**URGENT DEVICE
CORRECTION**

Problem Description Baxter Healthcare Corporation *(to be adapted locally)* is issuing a device correction for specific models of the Artis dialysis systems in order to update the current software versions to new software versions. The current version allows for the possibility of resetting and continuing patient treatment without following the instructions for addressing Alarm #642, "Arterial Chamber: Level Adjustment Required." This will subsequently deactivate the alarm for the remaining treatment time. The new software versions prevent the possibility of continuing the treatment without following the instructions for addressing Alarm #642, as written in the Operator's Manual.

Affected Product	Product Code	Product Name	Installation date
	110635	ARTIS 230V	<i>To be adapted locally</i>
	115323	ARTIS 230V Physio	<i>To be adapted locally</i>

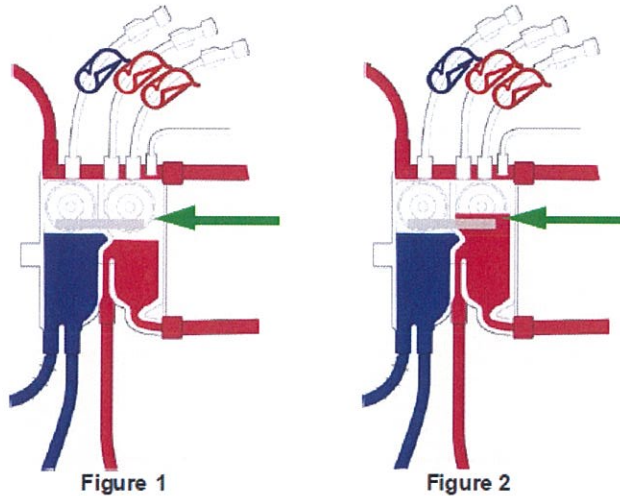
When the "Arterial Chamber: Level Adjustment Required (#642)" alarm occurs, check the blood level in the Arterial chamber while the Arterial pump is still stopped.

- If the blood level is below the frosted line, as shown in Figure 1, proceed with alarm troubleshooting to adjust the Arterial chamber level. Incorrect blood level may result in microbubbles smaller than 20 μL reaching the patient increasing the risk of air embolism.
- If the blood level is above the frosted line, as shown in Figure 2, grease the Pressure Transducers at the end of the treatment as described in the "13.13 Cassette Panel O-Rings Inspection and Greasing" section of the Operator's Manual. Improper greasing of Pressure Transducers may result in wrong arterial pressure measurements caused by ineffective Pressure Transducer and cassette coupling.

Actions taken by Baxter to avoid reoccurrence of the issue Baxter has developed new software versions for specific models of the Artis dialysis system. Baxter service representatives will begin contacting customer facilities in April 2017 in order to upgrade software versions. Until a new software version is installed on Artis machines, clinicians may continue to safely use the affected Artis dialysis systems, following instructions that are provided in the Current Operator's manual to address Alarm #642:
